S-Type	Date 07/99	S204-03
TECHNICAL BULLETIN

Subject REPLACEMENT SUSPENSION SPRINGS	Model S-Type Year 1999.25 Onwards VIN L00600 Onwards
--	--

Suspension spring and packing ring (arrowed)

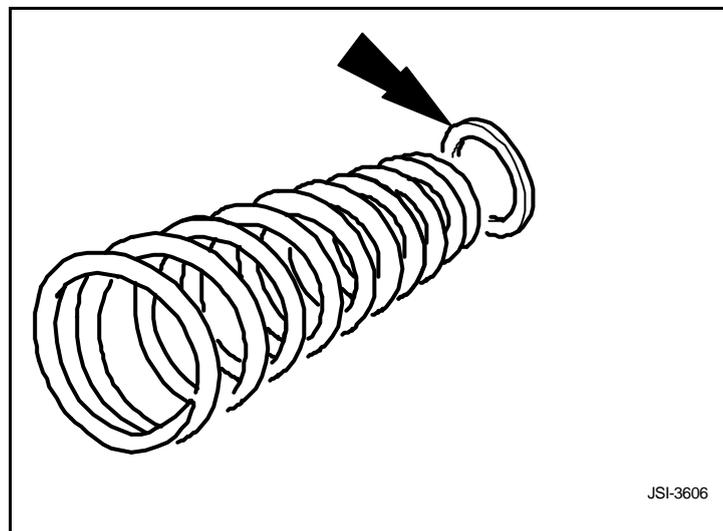
When 'short-tolerance' springs are built up into suspension assemblies, a 3mm packing ring is inserted under the spring, to maintain the correct ride height of the vehicle. No packing ring is fitted where 'long-tolerance' springs are assembled. Any one vehicle may have any combination of 'long-tolerance' and 'short-tolerance' springs fitted as original equipment.

All replacement springs supplied via Jaguar Parts Operations are selected as 'long' tolerance springs, and **must not** have packing rings fitted below them.

Where it is necessary to fit a replacement spring to an S-Type vehicle, examine the existing condition.

In any location where a 3mm packing ring is found under the existing spring, discard the packing ring before fitting the replacement spring.
